NEW MEXICO  
ENVIRONMENT DEPARTMENT

*Hazardous Waste Bureau*

June 1, 2012

**RE: APPROVAL WITH MODIFICATIONS  
FINAL, SAMPLING AND ANALYSIS PLAN  
(FIELD SAMPLING PLAN / QUALITY ASSURANCE PROJECT PLAN)  
REMEDIAL ACTION CONSTRUCTION AT SWMU 109  
CANNON AIR FORCE BASE, NEW MEXICO  
EPA ID # NM7572124454  
HWB-CAFB-11-006**

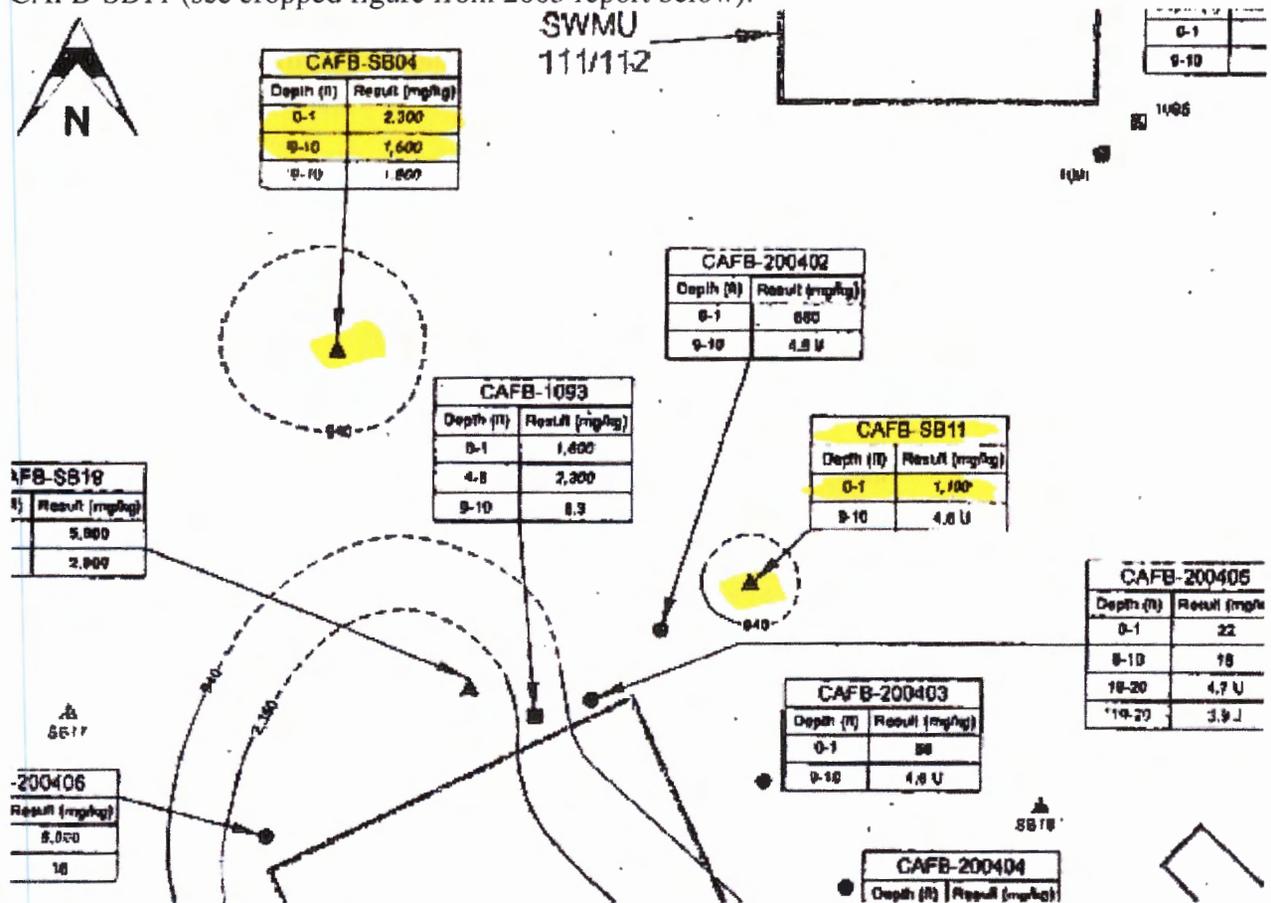
Figure 3, Sample Locations with Results, included in Cannon Air Force Base's (CAFB) 2005 "Phase I Investigation, Soil Corrective Measures, Fire Training Area 04" report depicts soil contamination exceeding current NMSSLs (see Comment 3) at locations CAFB-SB04 and CAFB-SB11 (see cropped figure from 2005 report below).

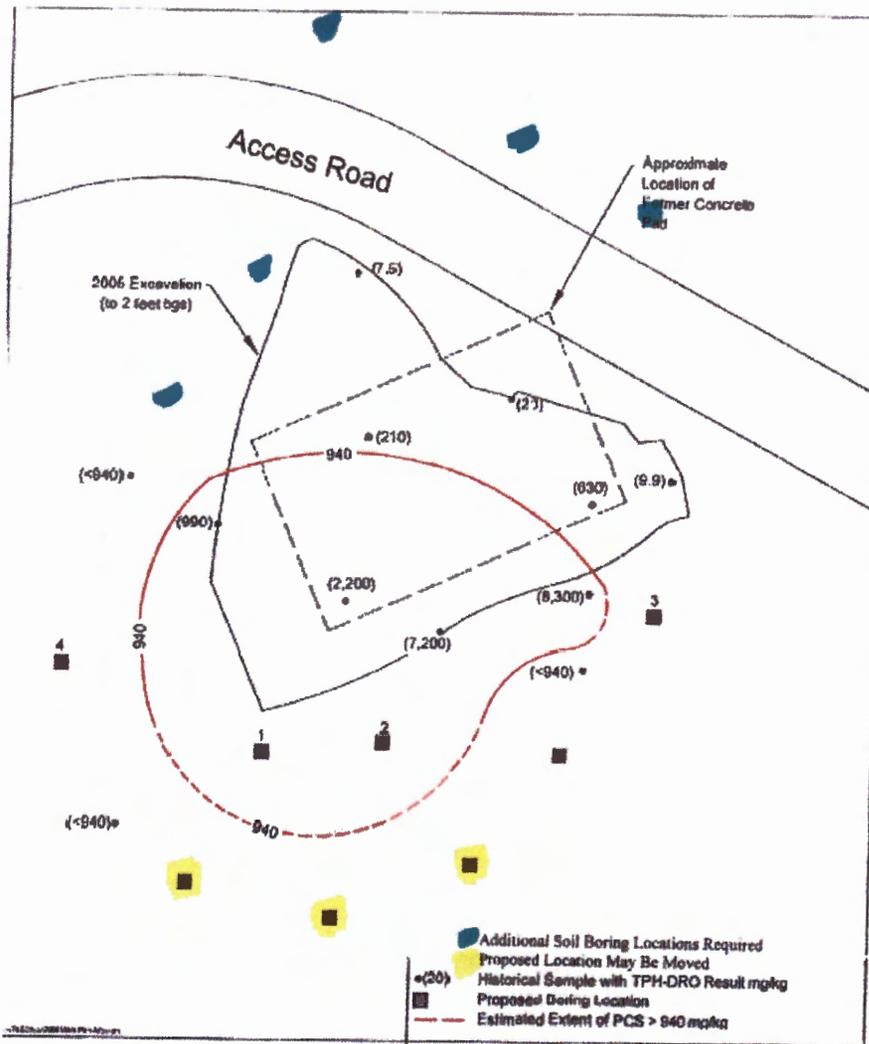
The results of excavation activities conducted at SWMU-109 in March 2005 are included in CAFB's 2005 "Voluntary Corrective Measures Report Fire Fighting Training Area No. 4 (FTA-04)" report. The report indicates that the soil removal action did not include the soil contamination in the vicinity of CAFB-SB04 and CAFB-SB11. **Figure 4, FT-C109 Conceptual Site Model** included in the Work Plan does not present the historical sampling locations for CAFB-SB04 and CAFB-SB11. The proposed excavation area presented in **Figure 5, Site Layout** of the Work Plan does identify soil contamination north of the previous excavation at SWMU-109 (see cropped Figure 4 from Work Plan below).

**QAPP Worksheet #11, Project Quality Objectives/Systematic Planning Process Statements, How much data should be collected, page 26, first paragraph** states "Eight soil borings are proposed to identify the TPH-DRO contamination and characterize the lateral and vertical extent of [contamination]" and **Figure 4, FT-C109 Conceptual Site Model** depicts the locations of eight soil borings to be installed. The proposed soil boring locations are in an area where according to telephone communications with the Permittee, the 2009 soil excavation activities have removed all contaminated soil as confirmed by analytical sampling activities. The Permittee may move the three proposed soil borings shown below to the area north of the previous excavation (see comment 7).

The Permittee must advance five additional soil borings to delineate soil contamination north of previous excavation boundaries. Locations for additional soil boring locations are depicted in the figure below.
